Item Name: Crosstube Turning Detail

DART AEROSPACE LTD		Work Order:	105221
Description: Crosstube Assembly (205/212 High Aft)		Part Number:	D212-664-241
Inspection Dwg: D212-664-241 Rev: D		Page 1 of 2

DRAWING NO. D212-664-241	TITLE CROSSTUBE ASSY (205/212 HI AFT)	REV. D	DART AEROSPACE LTD ENGINEERING ORDER		D.E.O. NO. D212-664-241-D-1	SHEET NO. SHEET 1 OF 2	SCALE NTS
DRAWN	CHECKED	MFG. APPR.	APPROVED	DE APPR.			
DATE 11.04.07	DATE 11.04.11	DATE 11.04.12	DATE 11/04/12	DATE 11.04.12

DRAWING NO. D212-664-241	TITLE CROSSTUBE ASS'Y (205/212 HI AFT)	REV. D	DART AEROSPACE LTD ENGINEERING ORDER		D.E.O. NO. D212-664-241-D-2	SHEET NO. SHEET 1 OF 1	SCALE NTS
DRAWN 92	CHECKED ASS	MFG. APPR. 18	APPROVED MP		DE APPR. H		
DATE 11.07.15	DATE 11.07.20	DATE 11.07.21	DATE 11/07/21		DATE 11-07-21

**D212-664-241/-241B
ASSEMBLY DETAIL**

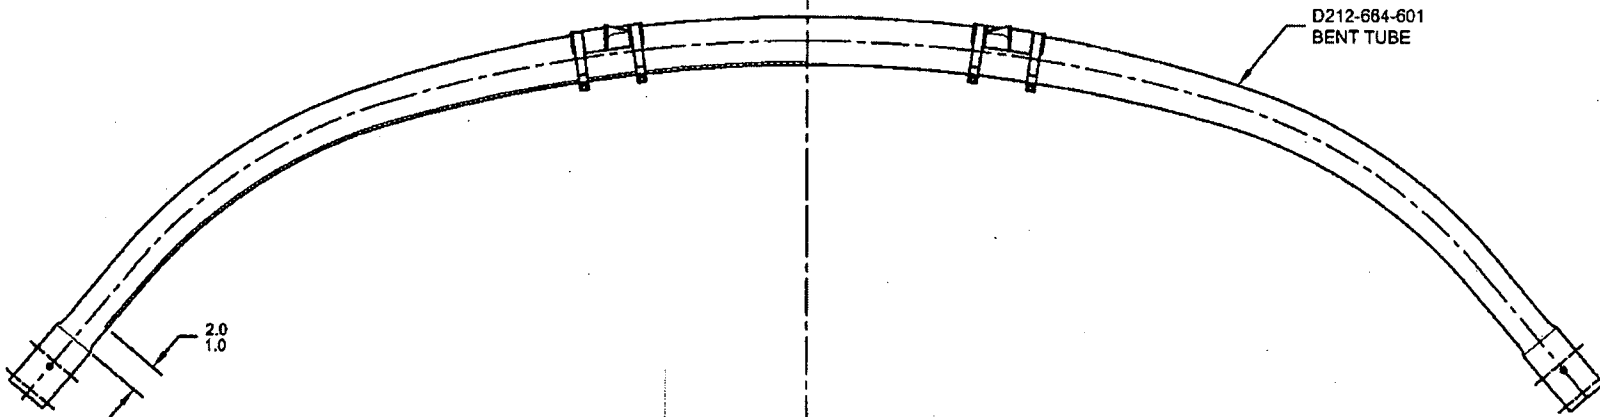
PURPOSE:

ADD AN INSPECTION WINDOW TO UNDERSIDE OF CROSSTUBE.

NOTES 2 OF SHEET 1 IS AMENDED AS FOLLOWS:

IS:

MASK AREA PRIOR TO PAINTING,
REMOVE MASKING AFTER PAINT
AND APPLY CLEAR COAT

- 2) FINISH: CHEMICAL CONVERSION COAT PER DART QSI 005 4.1
PRIME INSIDE AND OUTSIDE PER DART QSI 005 4.2
MASK UNDERSIDE OF CROSSTUBE AS SHOWN (HATCHED AREA) AND
PAINT OUTSIDE PER DART QSI 005 4.2
REMOVE MASKING AND APPLY CLEAR COAT
